MELBOURNE METRO RAIL PROJECT ENVIRONMENT EFFECTS STATEMENT
INQUIRY AND ADVISORY COMMITTEE

MMRA TECHNICAL NOTE

TECHNICAL NOTE NUMBER: 067

SUBJECT: Response to the ‘Matters for further consideration and/or clarification’ request dated 12 September 2016

MELBOURNE METRO - EASTERN PORTAL
William Street - Section view

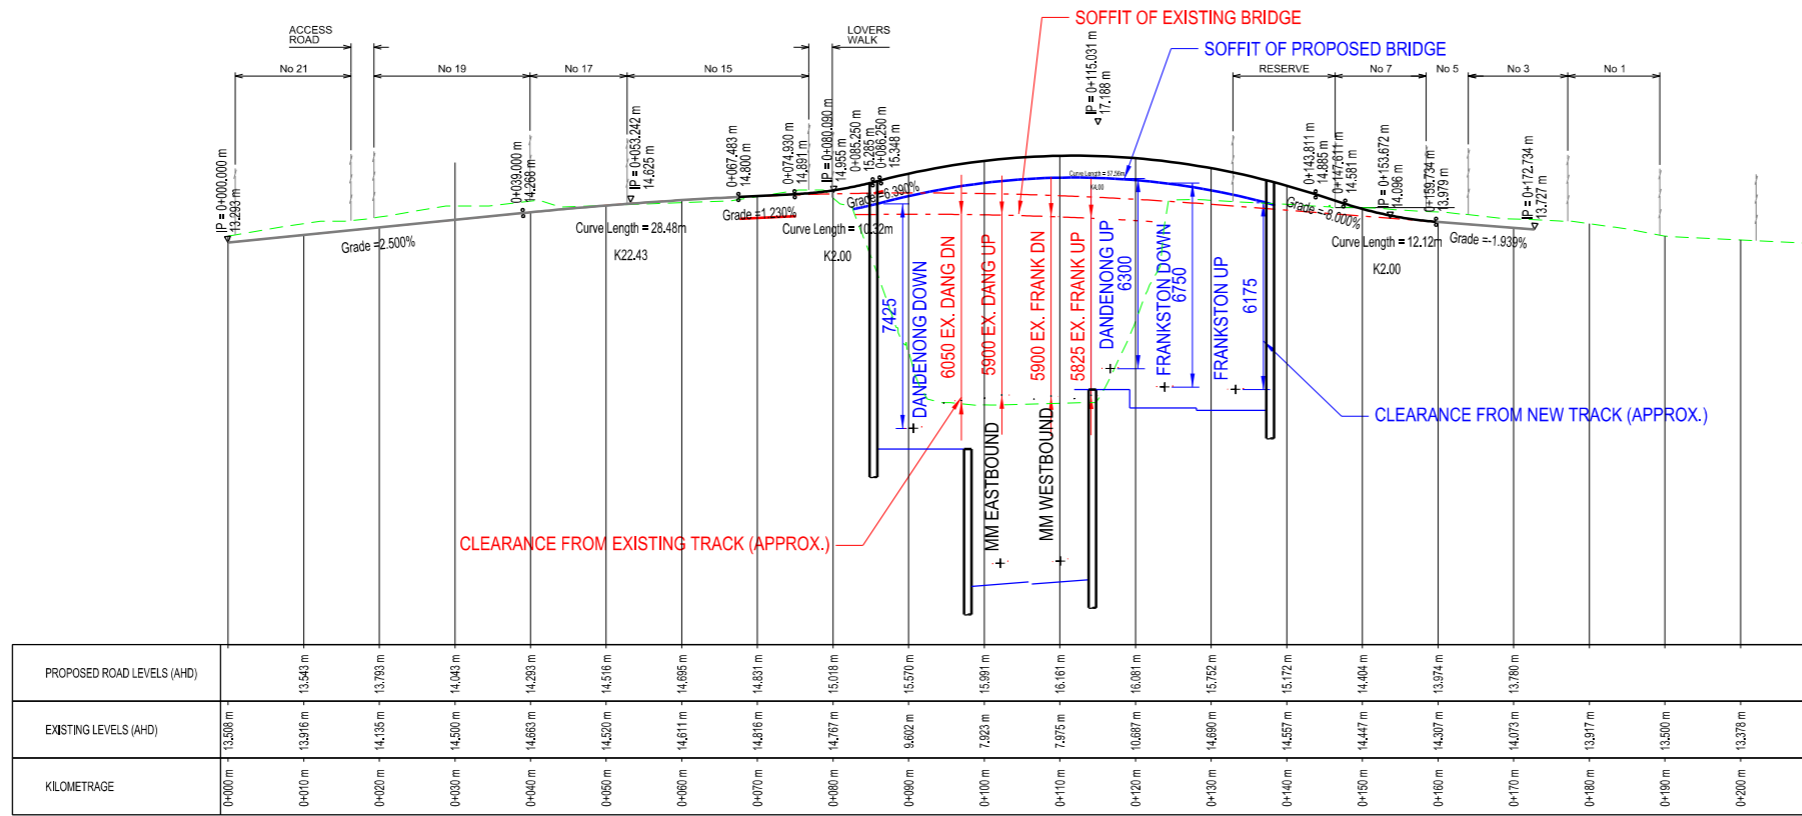
Information about the proposed height of the William Street Bridge and confirmation of its reinstatement for vehicular traffic.

20. The section on map book reference “MMR/AJM/PWAA/MP/NN/500301” (Sheet 15 of 15) which illustrates the proposed height of William Street bridge is correct.
21. The proposed William Street bridge level shown in the Vertical Profile in Sheet 15 of the EES Map Book is the same as the existing bridge level directly above/below the westbound track centreline, where William Street is at a higher point.

22. William Street Bridge will be reinstated for vehicular traffic and will tie back into the existing levels. See **Attachments A and B** to this Technical Note.
